Re: Responses to Preliminary/Final Land Development Plan Comments
LCBC Church
1400 Church Road
Manchester Township, York County, PA
SDC# 1590.1

Re: LCBC Church-1400 Church Road
Preliminary/Final Land Development Plan
Manchester Township Plan #2025-12
Engineer's Project No. 0841.3.12.53

PRELIMINARY/FINAL LAND DEVELOPMENT PLAN PROPOSED HOUSE OF WORSHIP

SCALE		AS NOTED
DRAWN BY	LM	
CHECKED BY	TBE	
DESIGNED BY	TBE	
DATE	09.03.25	
FILE NAME	1590.1-LD-1	
AS NO.	1590.1	
SHEET NO.	C-1	1
SHT. 1 OF 20

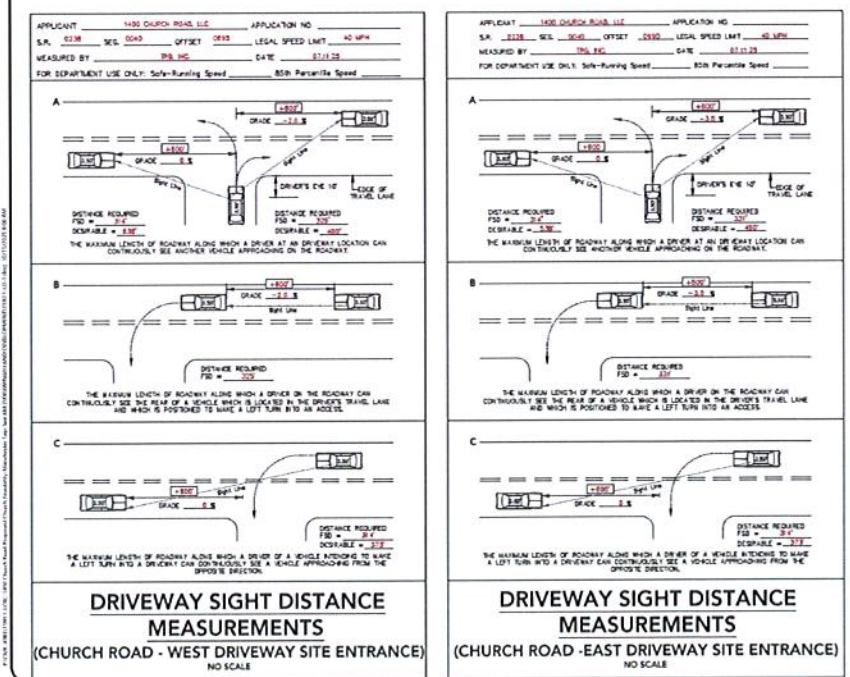
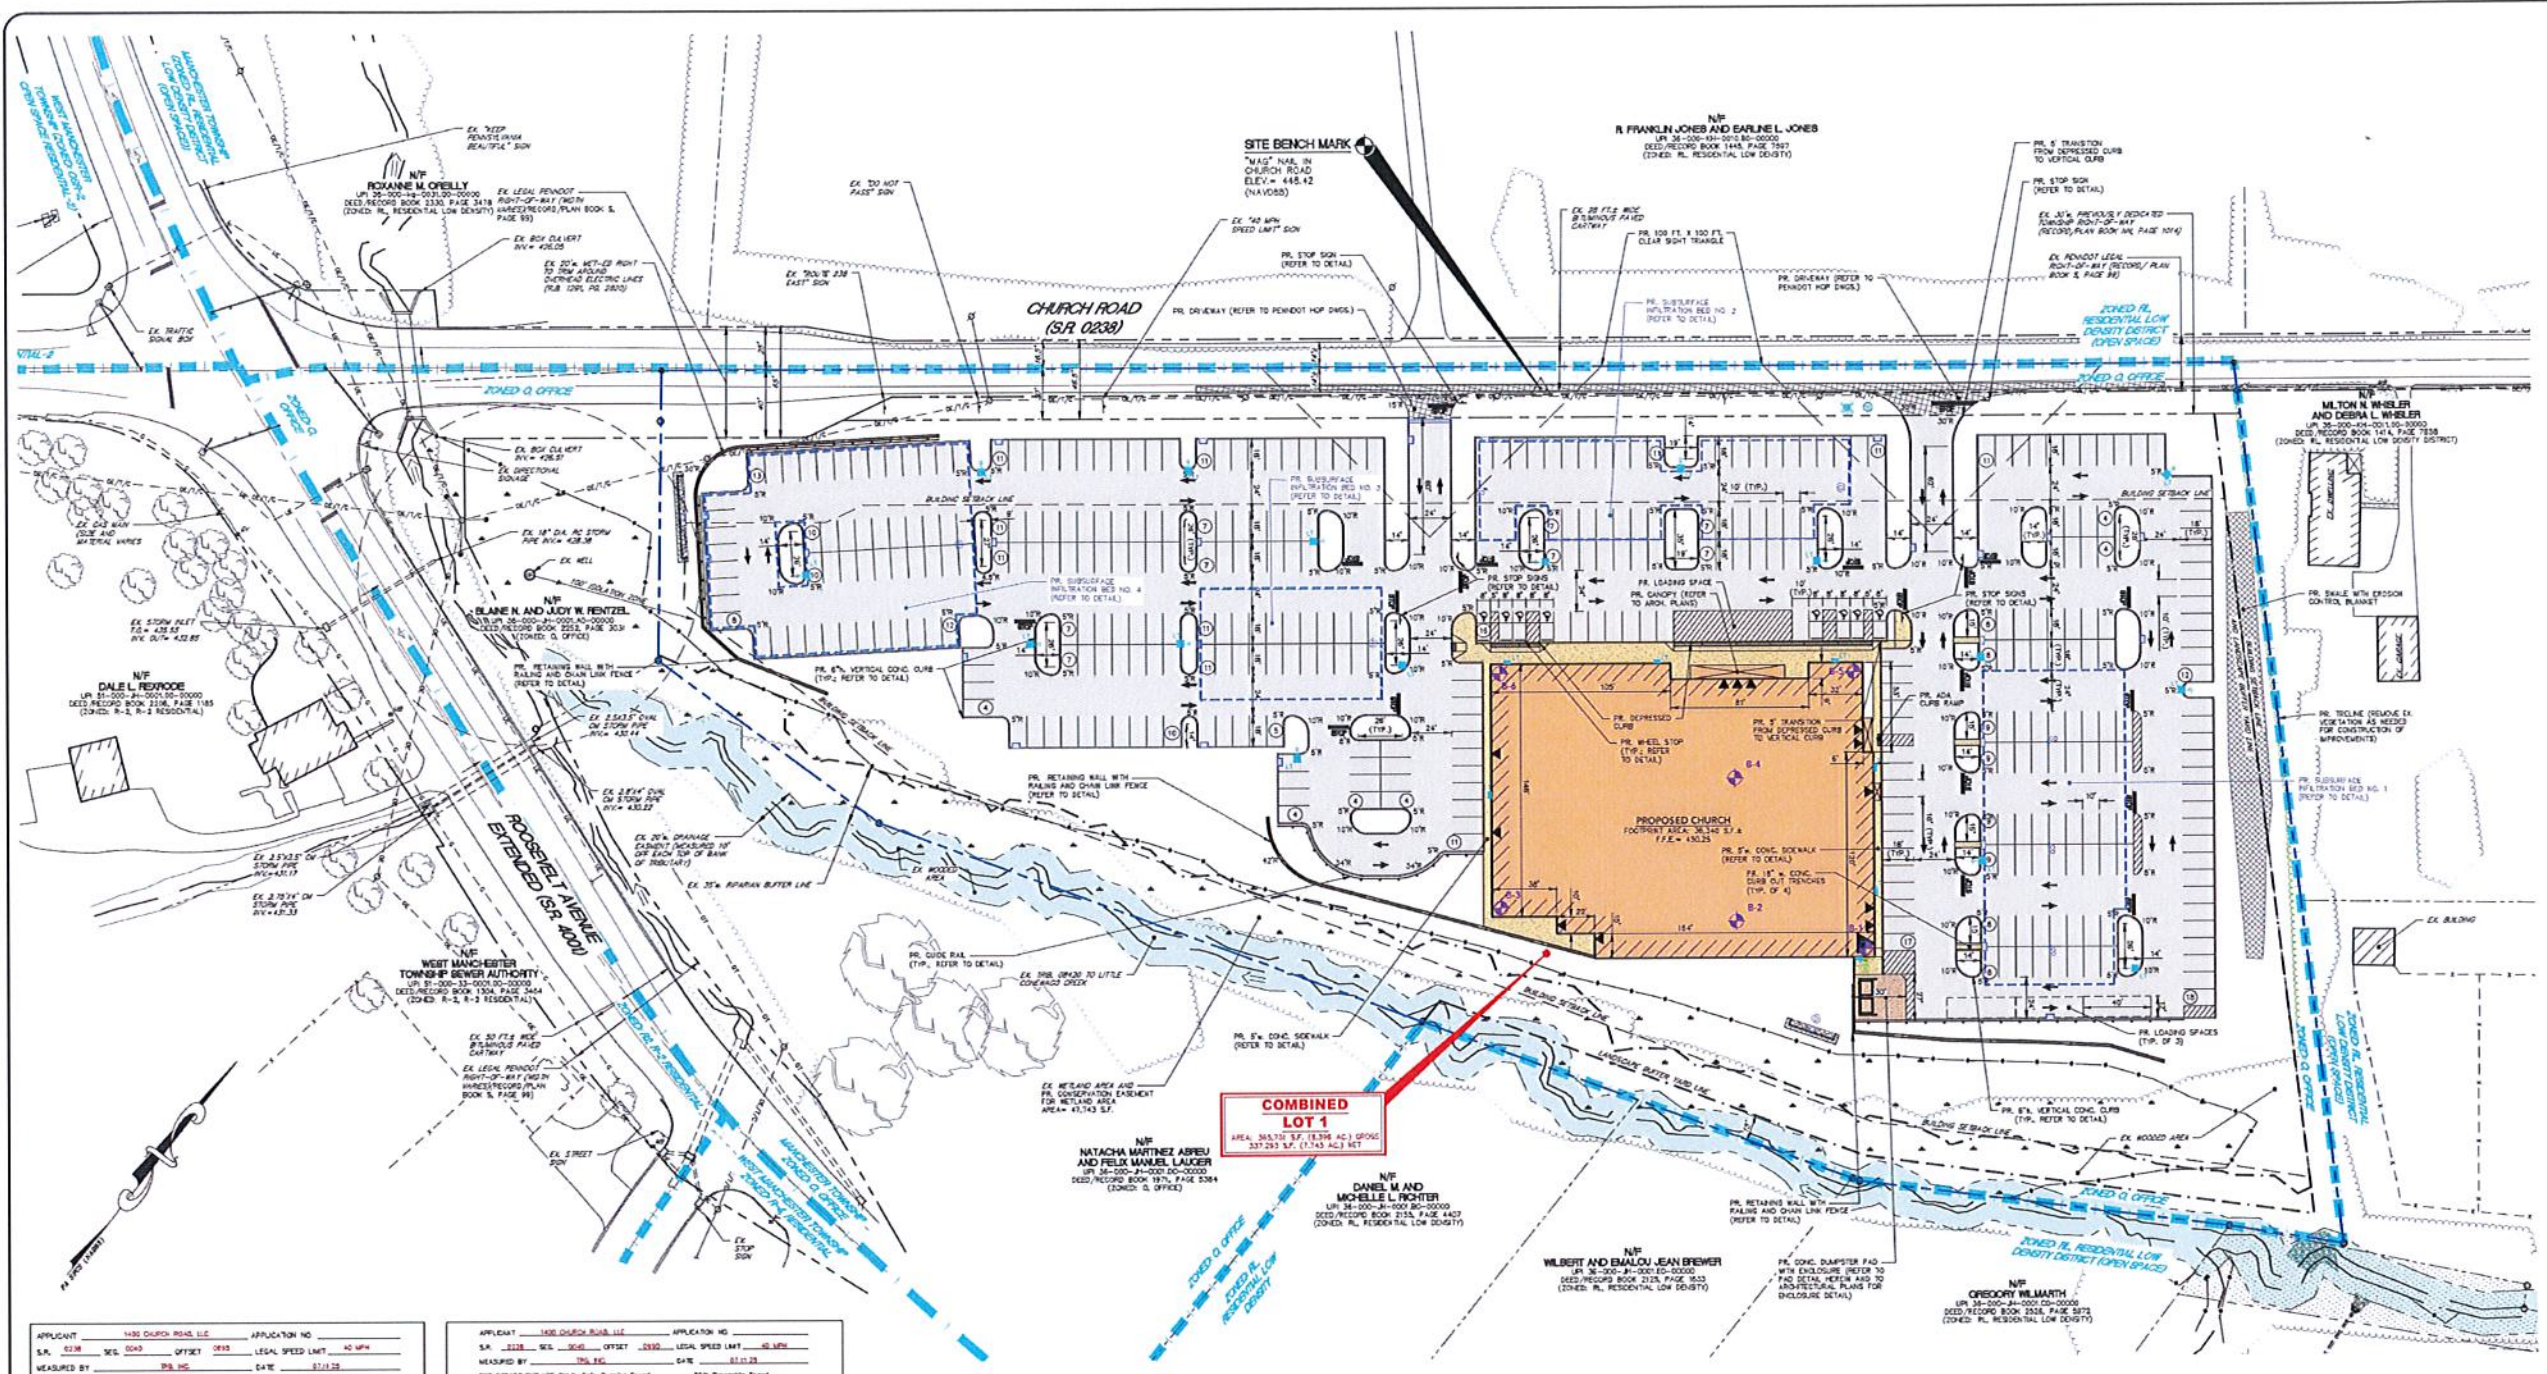
26. A statement of ownership, acknowledgment of the plan, and offer of dedication shall be provided on the coversheet of the plans and the owner's notarized signature shall be added (§22-406.1.2).

28. The responsible professional's signature block, along with seal and dated signature shall be added to the cover sheet. (§22-406.1.4)
29. The Carbonate Geology Statement shall be executed.

1. Section reference for waiver #1 has been revised.
2. Acknowledged. Fire truck turning template has been revised to be shown at a larger scale.
3. Address for the lot is stated in the uniform parcel identification block on the title sheet.

24. Acknowledged.
25. Plans are currently under review by York Water Company.
26. A statement of ownership, acknowledgement of the plan, and offer of dedication has been added to the plan.

DRAWN BY:	LUN
CHECKED BY:	TBE
DATE:	09.03.25
FILE NAME:	1590.1-LD-1
ASR NO:	1590.1
SHEET NO:	C-5
SHT. 5 OF 20	1

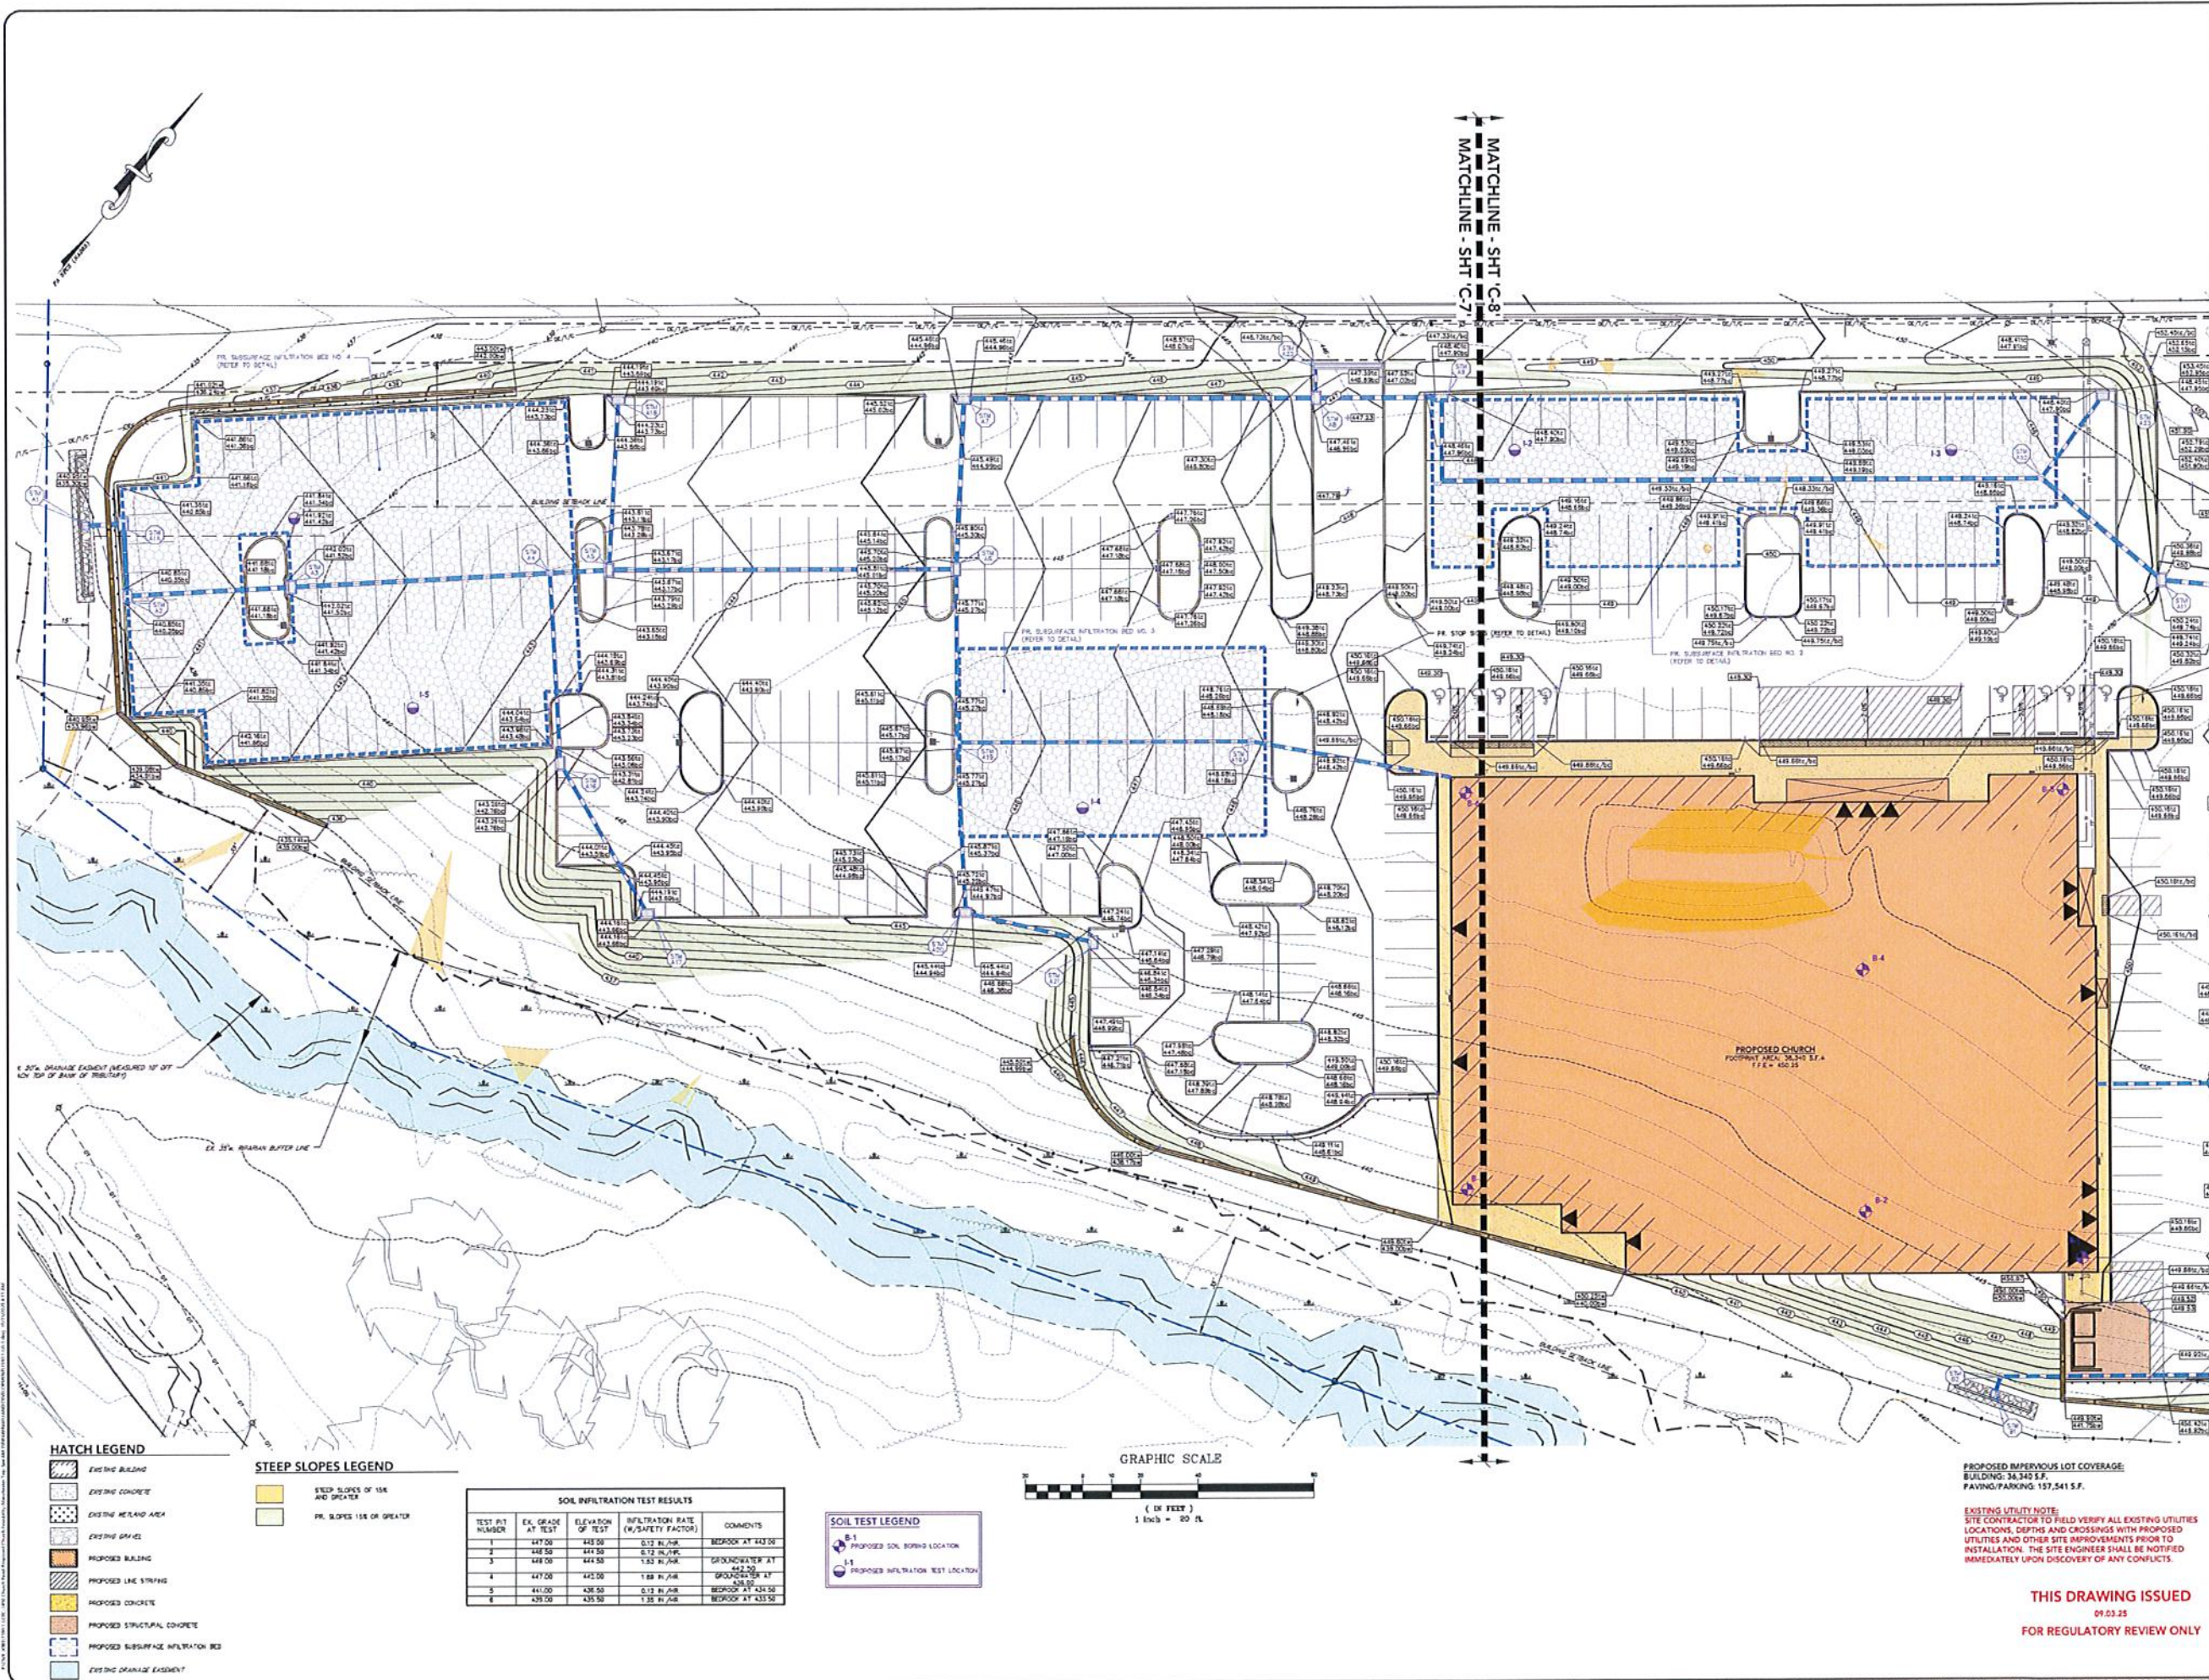
10. Dimension the proposed Church building. (§22-406.4.46)
11. Dimension the length of the proposed access drives. (§22-406.4.50)
12. All existing traffic control devices (signage) shall be shown on the plans. (§22-404.4.51)

13. Loading spaces shall be dimensioned on the plans. (§22-404.4.52)
14. Islands within the parking area shall be dimensioned on the plans. (§22-404.4.51)

10. The proposed church building has been dimensioned.
11. Proposed access drive lengths have been dimensioned.
12. All proposed traffic control signage has been shown on the plan.

13. Proposed loading spaces have been dimensioned.
14. Proposed Interior parking islands have been dimensioned.
15. A 20' wide drainage easement has been provided for Tributary 08420 to Little Conewago Creek.

SCALE	AS NOTED
DRAWN BY	LJM
CHECKED BY	TBE
CONTACT	TBE
DATE	09.03.25
FILE NAME	1590.1-LD-1
JOB NO.	1590.1
SHEET NO.	C-11
SHT. 11 OF 20	1

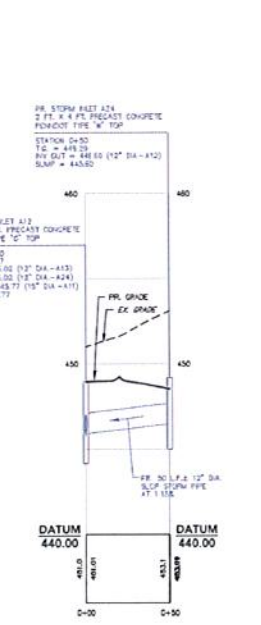
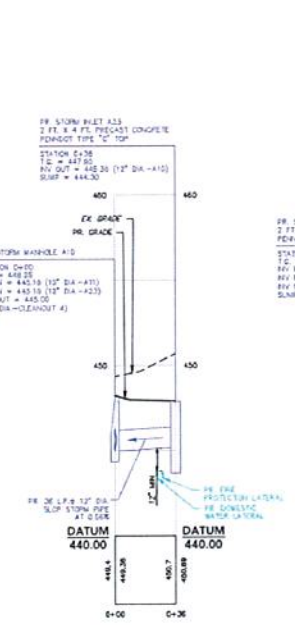
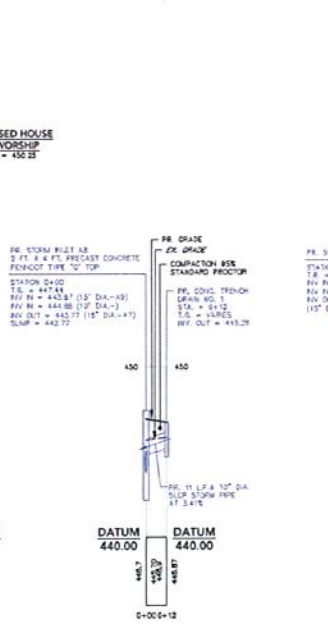
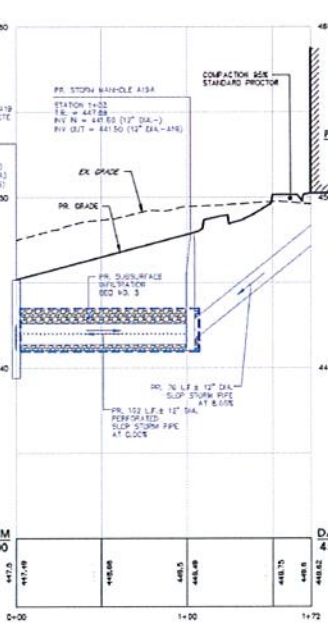
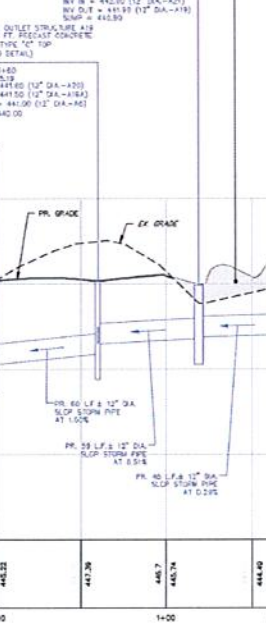
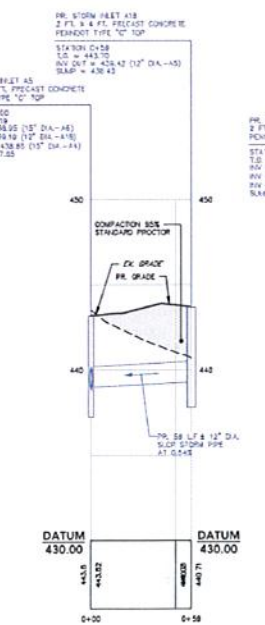
1. Grate elevation B of trench drain #3 is 494.34' however, it is downhill of the 494' contour.
Response: The grate of elevation of Trench Drain #3 has been revised in the plan and details accordingly, as depicted on Sheet 4.00 and Sheet 11.00, respectively. Please note that the grate elevation varies along the length of the trench drain.

**TYPICAL CHURCH ROAD (S.R. 0238)
CROSS SECTION**
NO SCALE

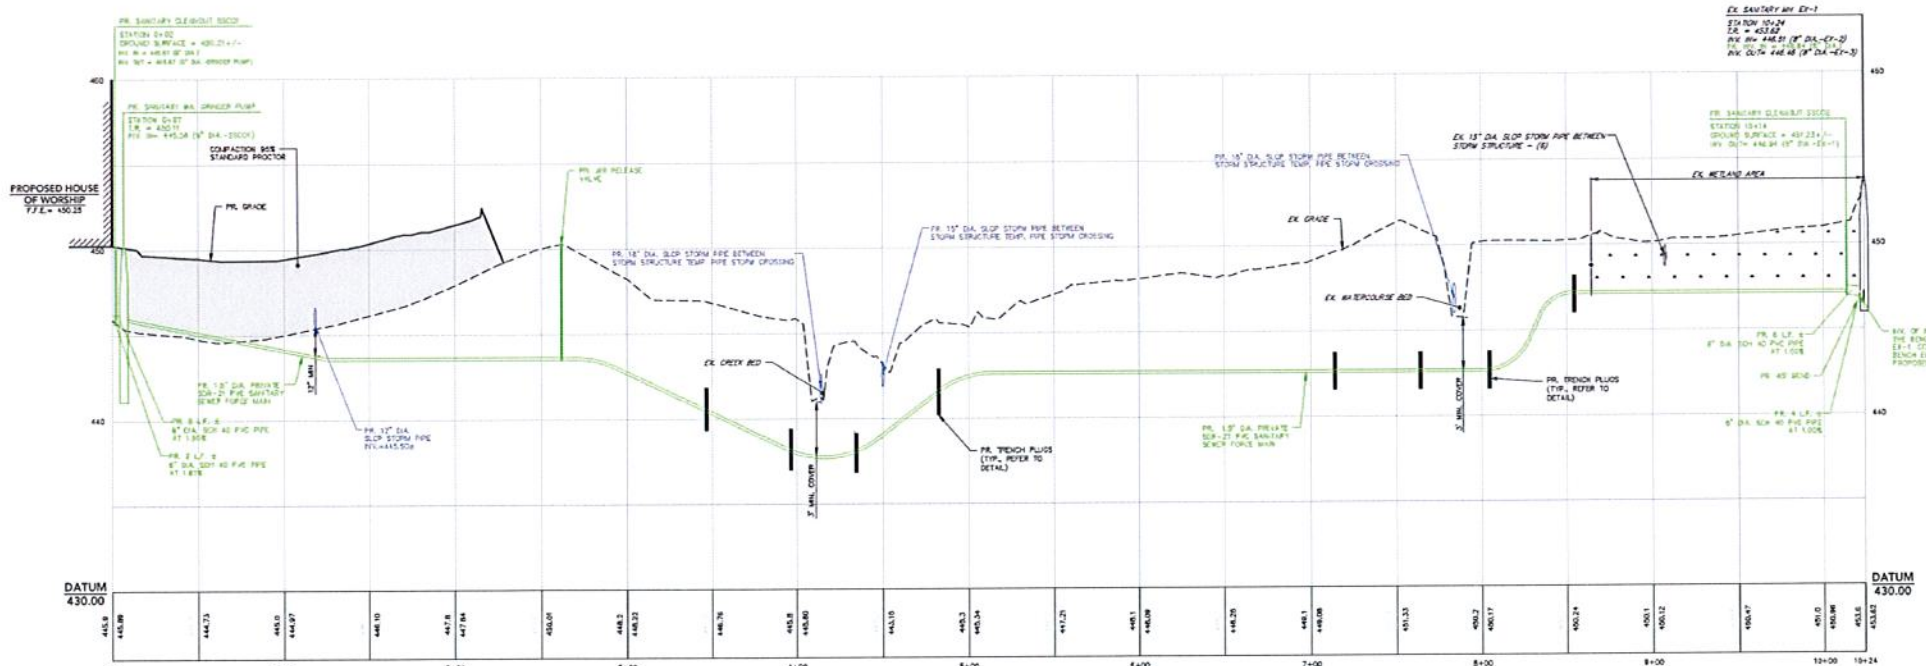
1. A pavement restoration detail shall be added to the plans for Church Road.
2. Guide rail shall be added to the plan legend.
3. Revise the discrepancy on the pipe sizing of sanitary sewer service between the plans and profiles.
4. A detail shall be provided on the plans for the proposed trench plugs along the force main alignment.
5. Curbing should extend around the access drive radii and taper on Church Road.

1. A pavement restoration detail has been added to the plan for Church Road.
2. A guide rail has been added to the plan legend.
3. The pipe sizing for the private sanitary sewer force main has been revised to be consistent between the plans and profiles.
